Corrigendum - 4 dated 20/12/2025 to CPC Tender No. BHEL/CPC/KOD/EPC_AHP_PKG - II/26/058

Corrigendum - 4 dated 20/12/2025 to CPC Tender No. BHEL/CPC/KOD/EPC_AHP_PKG - II/26/058 for the work of “EPC Package (Package – II) for Main Ash Handling System of Unit#3 & Unit#4 at 2x800 MW DVC Koderma TPS Phase-II, Jharkhand”.

AMENDMENT NO. 6 TO BID SPECIFICATION

Technical Corrigendum-01

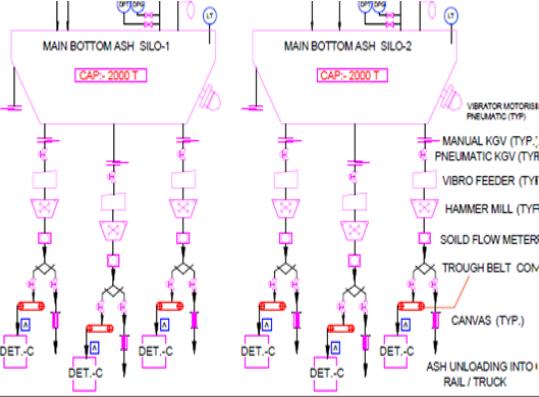
64	Drawing No.: XXXX-001('R)-POM-A-029	Single Line Diagram for Fly Ash Classification System (For Pressure Conveying System)	<p>In the said Flow Scheme, 02 Nos. (1W+1Sb) Coarse Fly Ash Hoppers & 01 No. Fine Fly Ash Hoppers is envisaged for Fly Ash Classification System for all the three units.</p> <p>#) 01 No. Fly Ash Classifier is shown at the top of Working Coarse Fly Ash Buffer Hopper.</p> <p>#) There are 06 Sets. of Ash Conveying system below each Coarsae Fly Ash Hopper & 02 sets. (01W+01SB) below</p>	Bidder is requested to refer <u>DVC amendment No 6 to bid specification along with the technical specification (attached along with this corrigendum).</u>

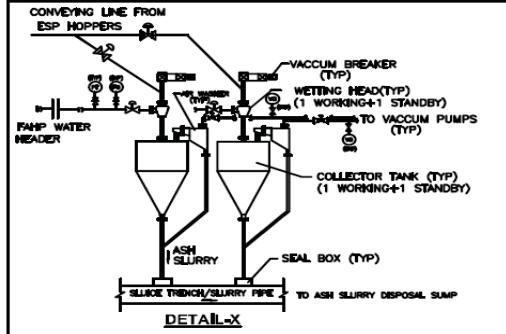
69	2-TCC TECHNICAL CONDITION OF CONTRACT Cl. No. 03.02.05 Ash Handling Conveyor system from BAIM Silo page 30 of 120	4. Separate Pump house with compressor, pumps and all associate accessories (with 100% standby system) for Service water, drinking water, Fire Water and DFDS system to be consider by bidder.	<p>1) Owner is requested to kindly clarify the quantity & type of all equipment to be located in this separate pump house.</p> <p>2) Also provide the type (RCC / Steel shed) & location of the pump house.</p>	<p>1. Bidder to follow technical specification.</p> <p>2. Pump House will be of RCC.</p> <p>3. Location of DFDS Pump House is shown in the plot plan.</p>

DWG NO.-3112-108-POM-A-910

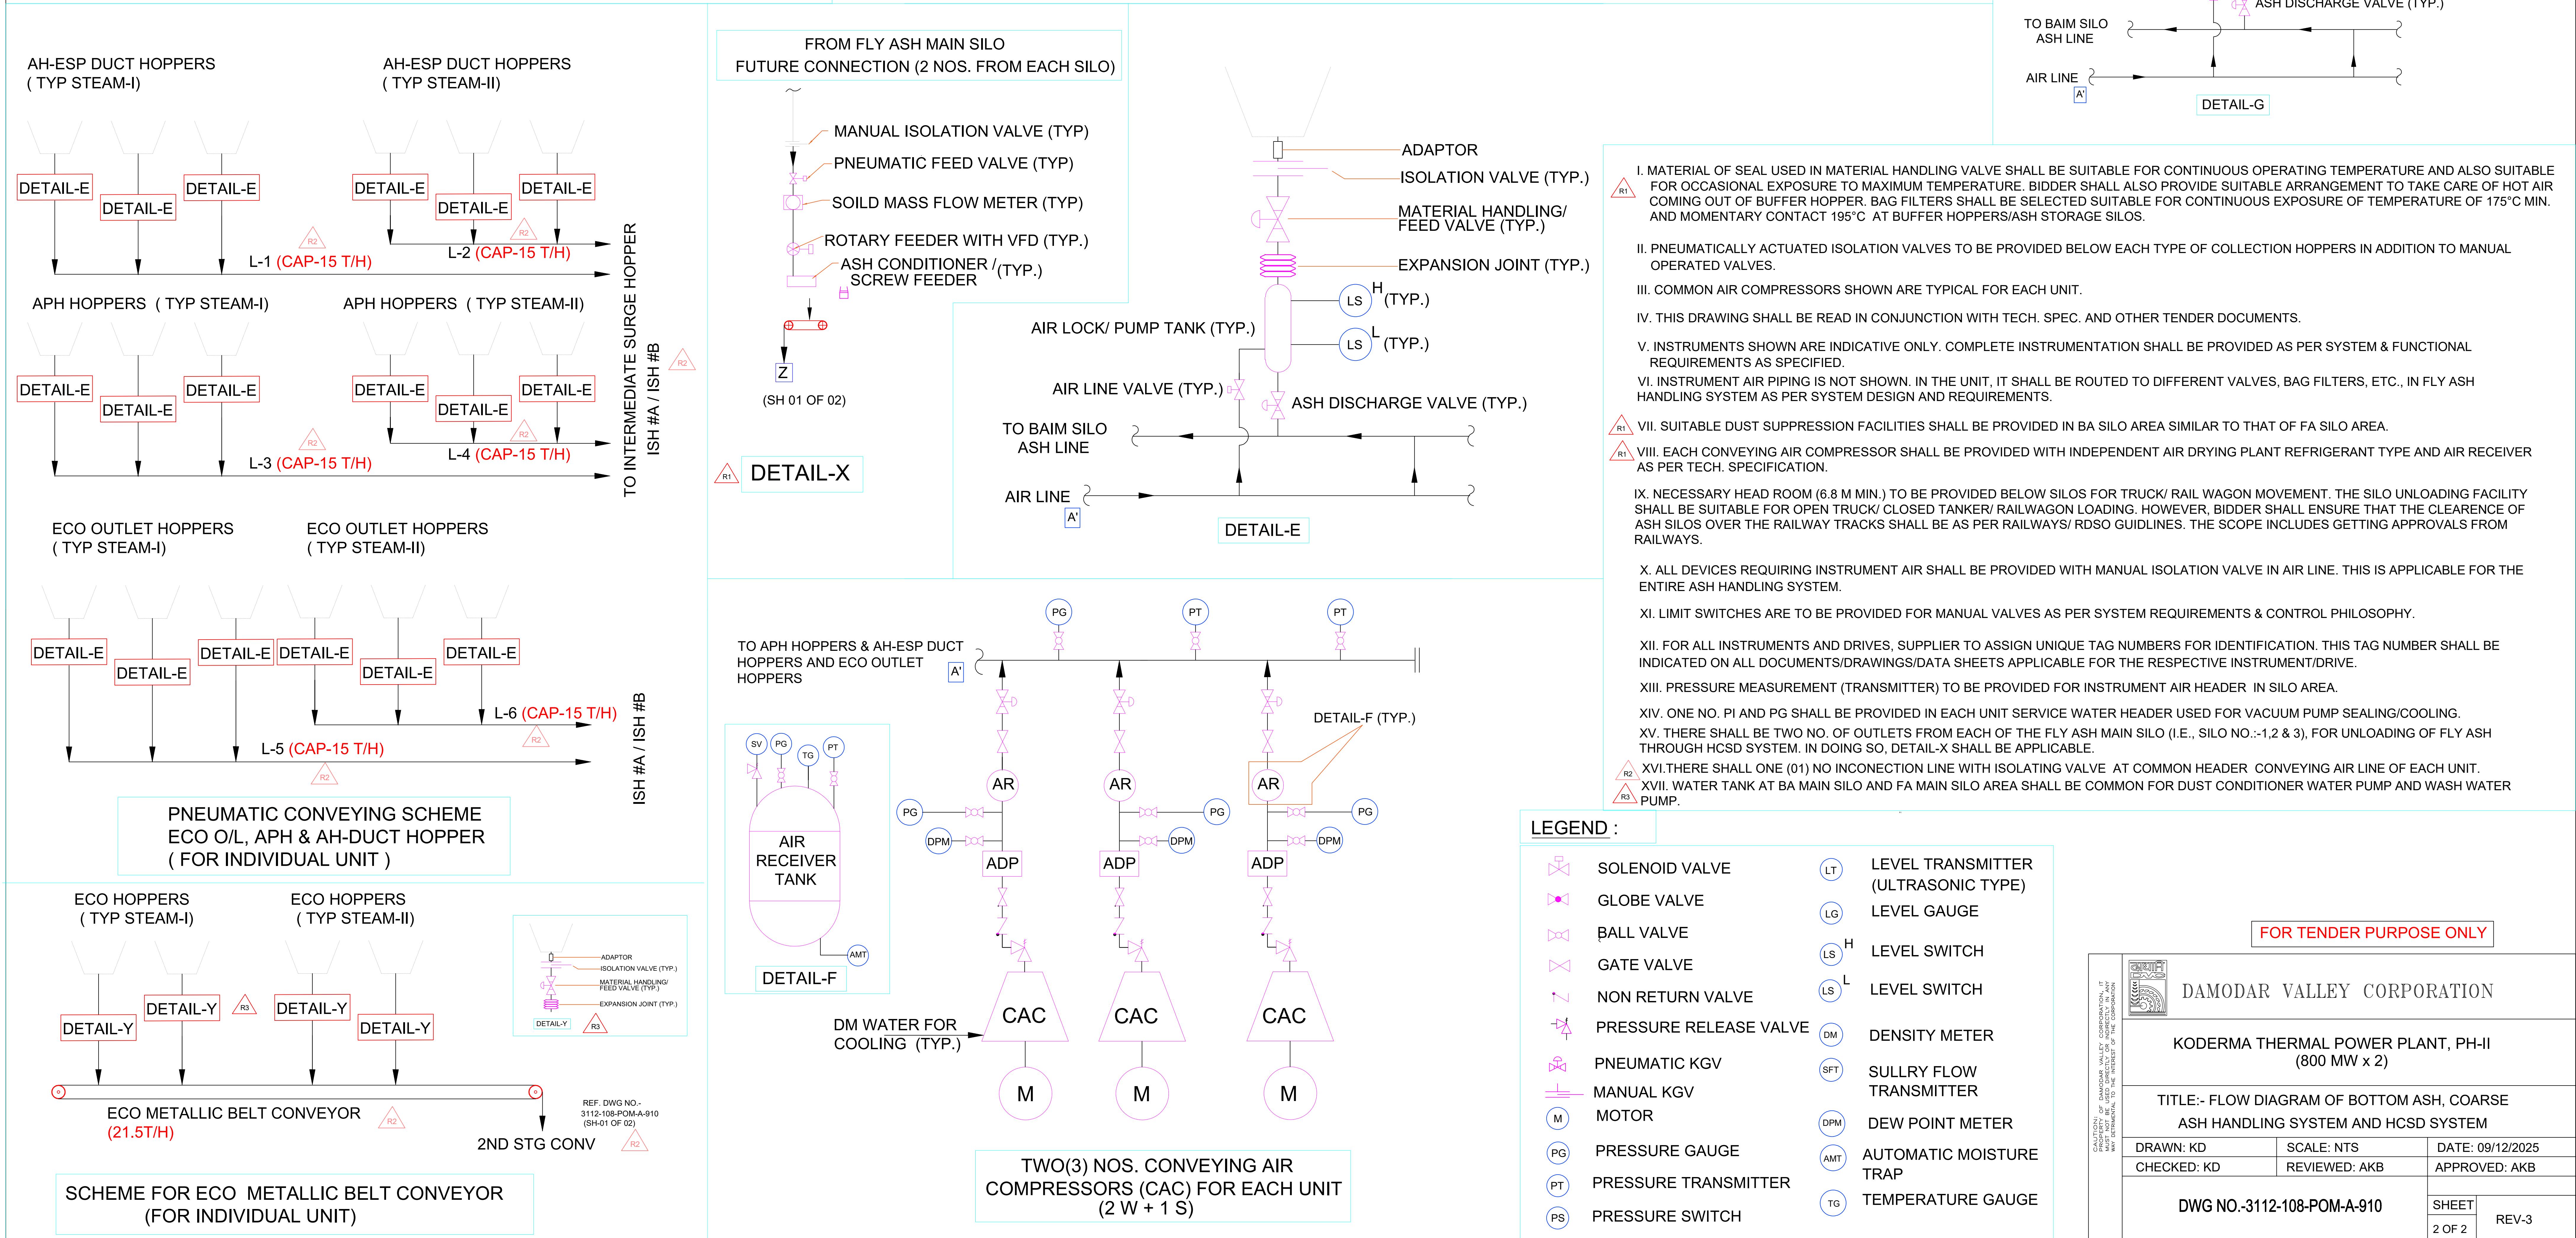
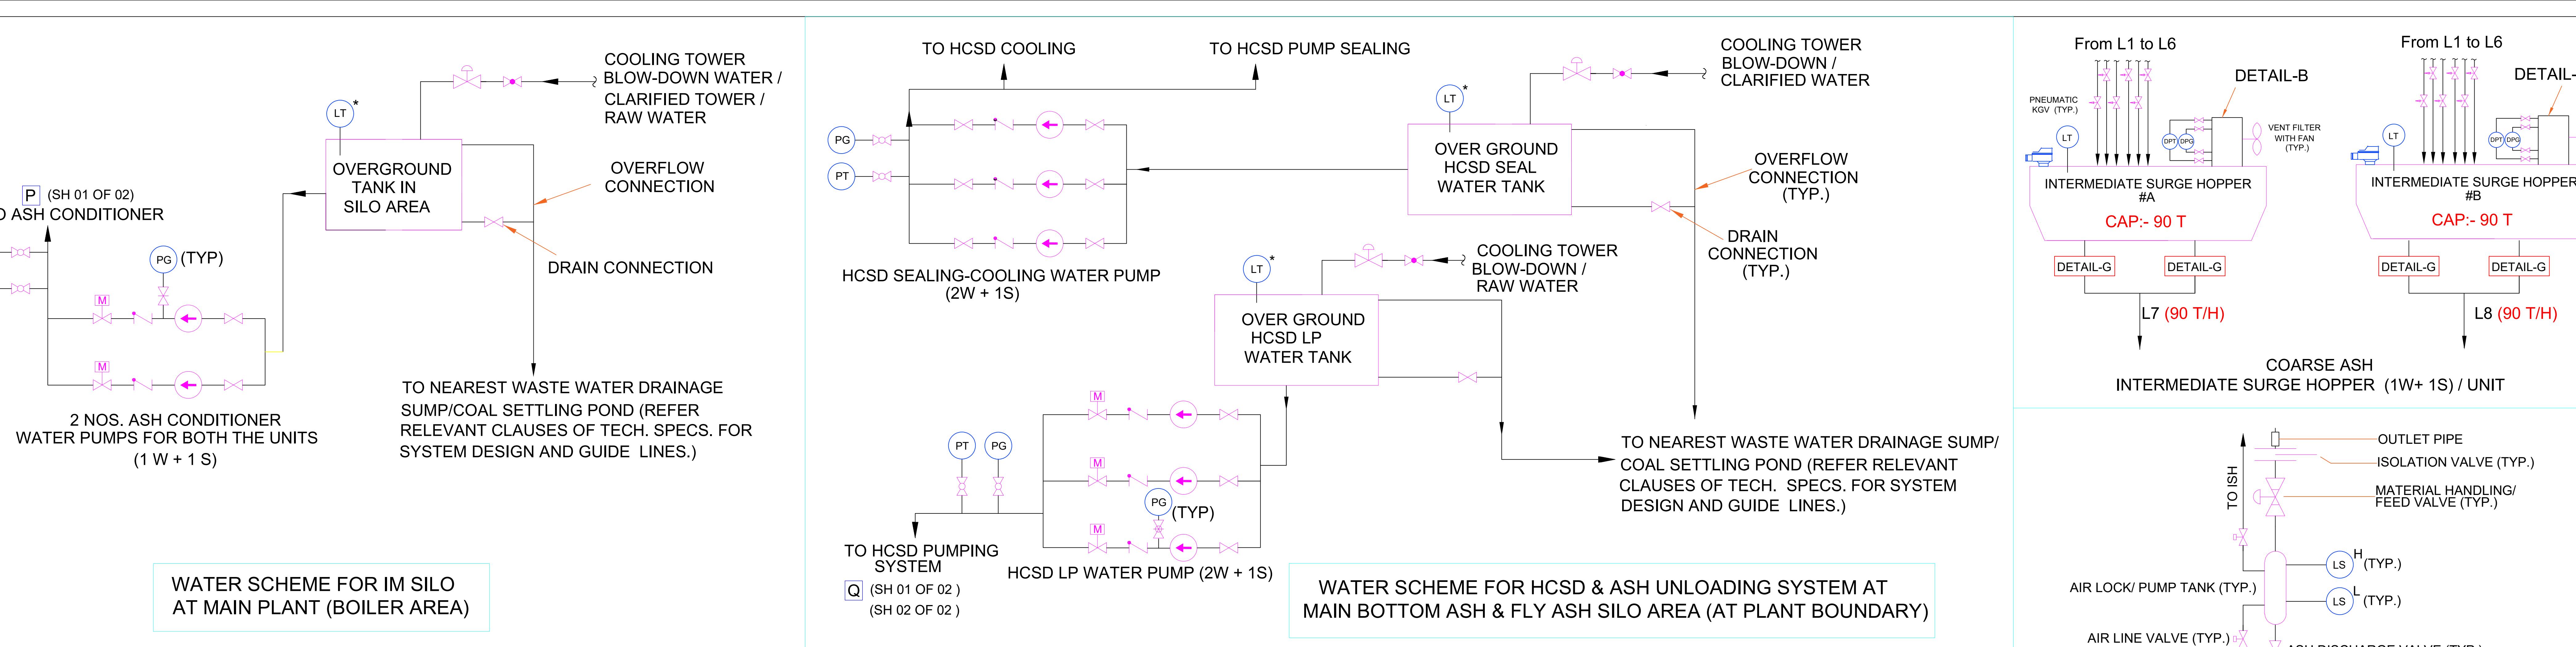
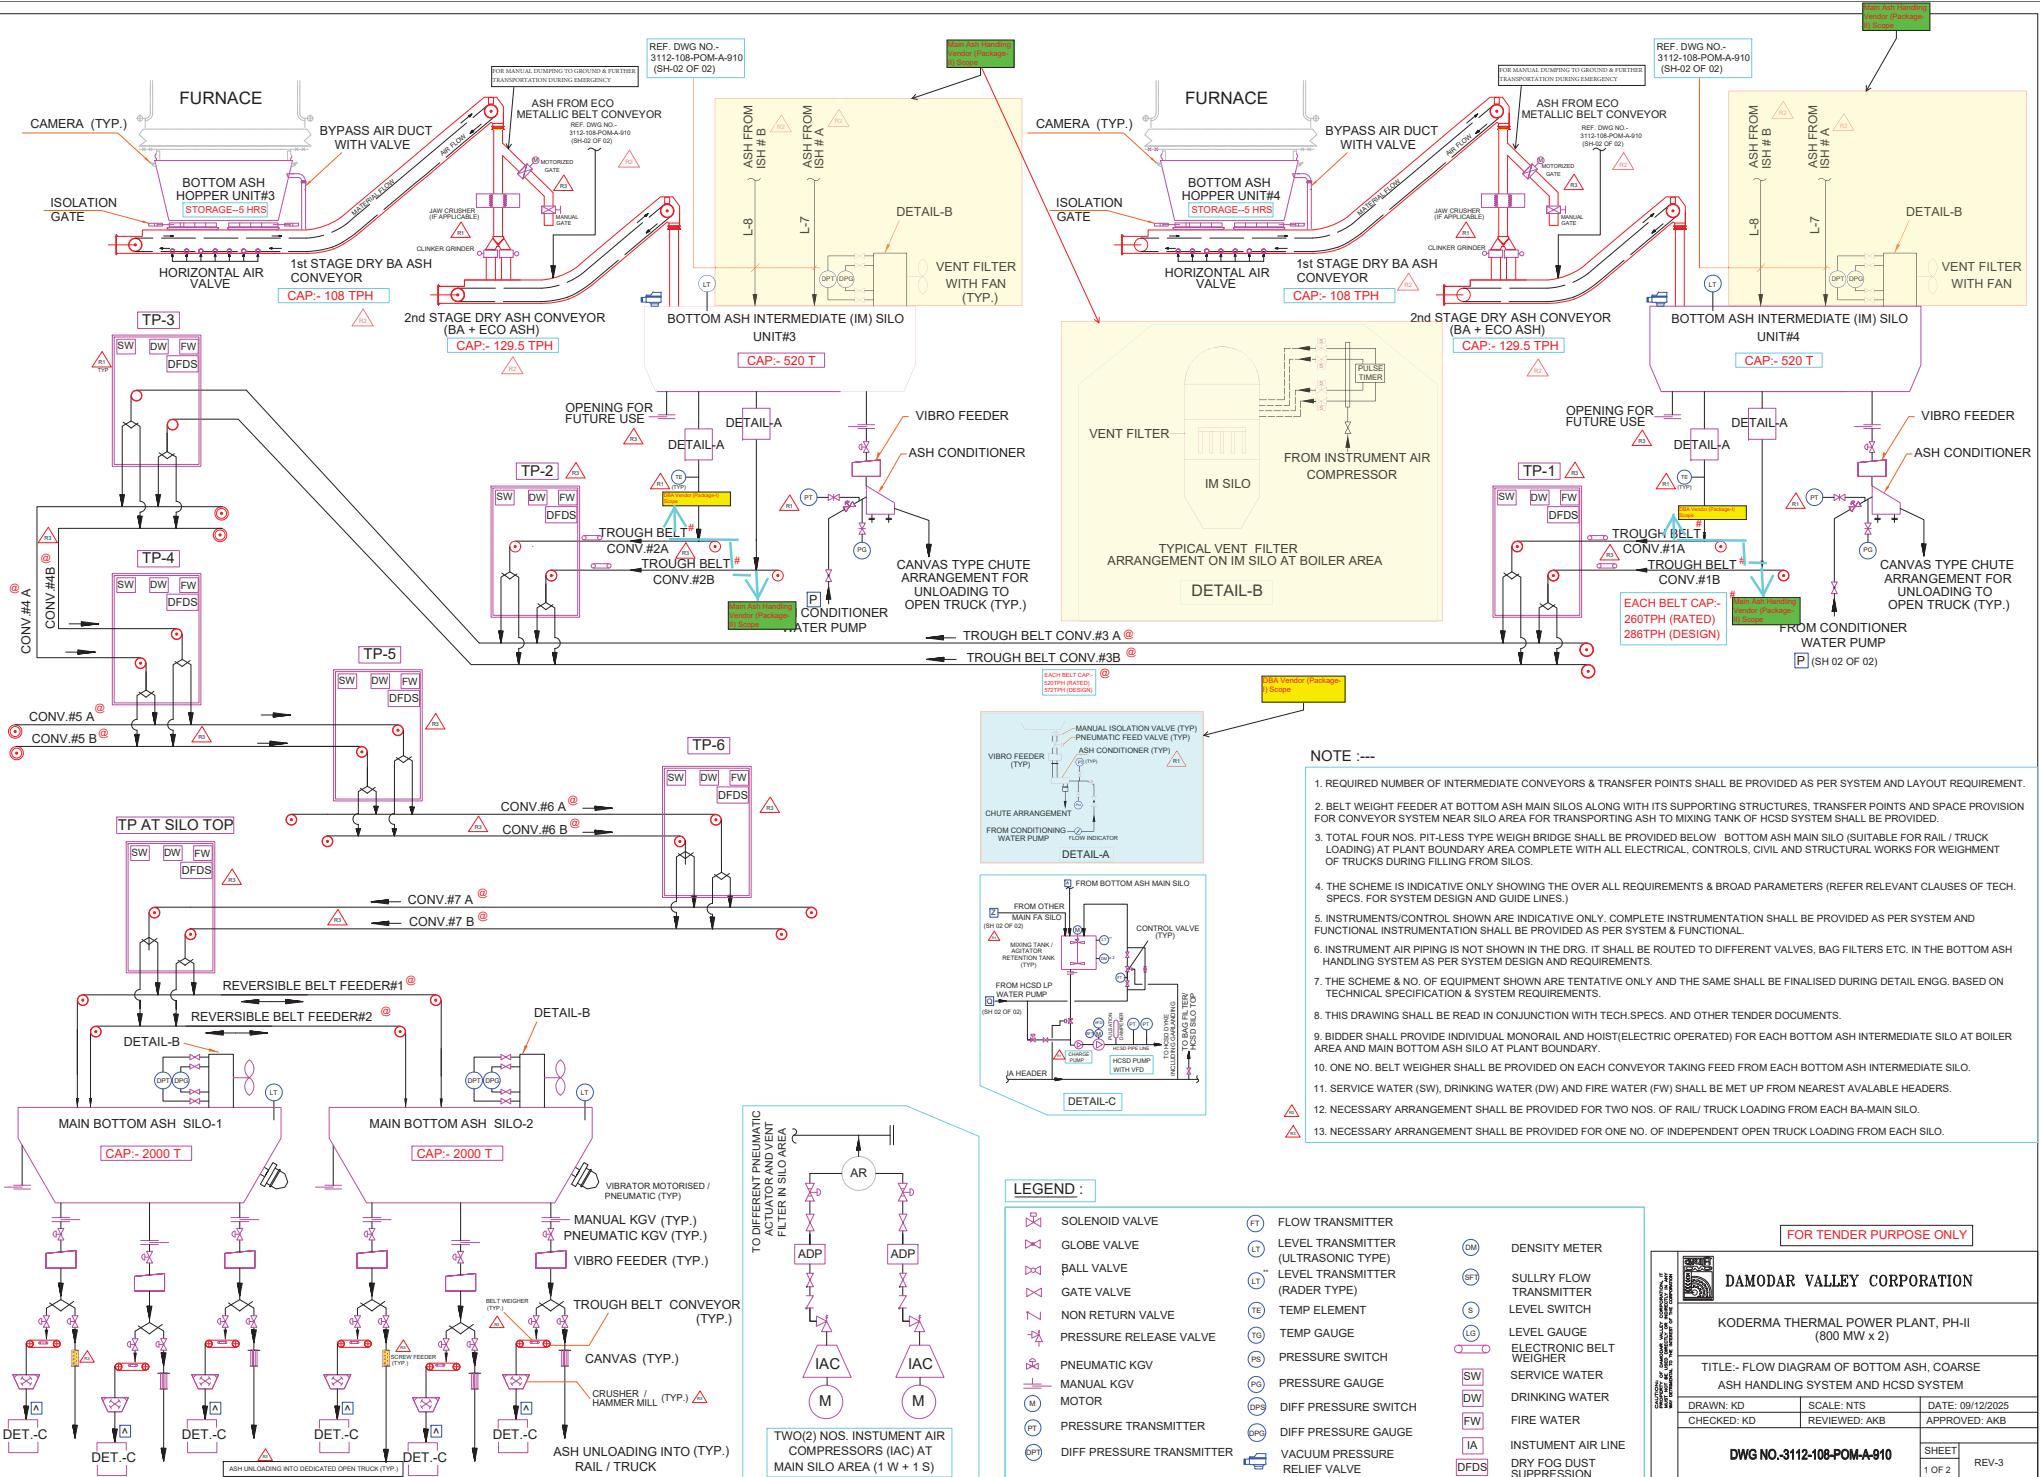
2.		General	<p>Please find Flow Diagram for Bottom Ash, Coarse Ash and HCSD System with Scope demarcation of Interface portion between Package-I and Package-II. However, bidder shall read the specification and scope matrix for detail scope.</p>
